Re: **Review of Shoppes at Concord**

On behalf of Chadds Ford Township, Systems Design Engineering, Inc. (SDE) has reviewed plans, reports, and correspondence regarding the Shoppes at Concord to identify potential impacts to the Township. Note that this is not a comprehensive review of all plans and reports but is meant to serve as a high level review to help further the discussion and potential impacts that this project entails.

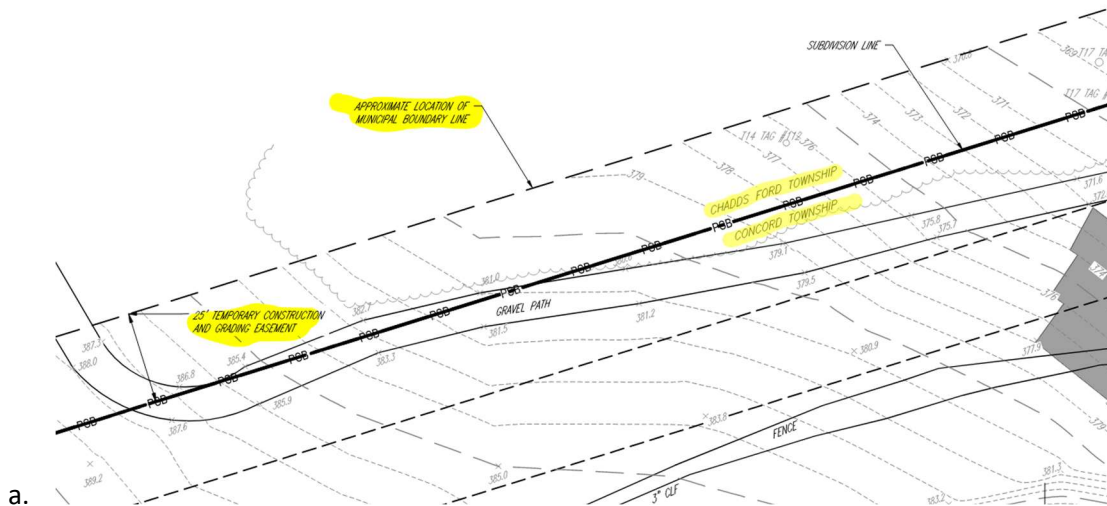
1. The Township boundary should be confirmed via professional surveyor to demonstrate that none of the project lies within the Township. The plans have conflicting information regarding the Township boundary as shown below:
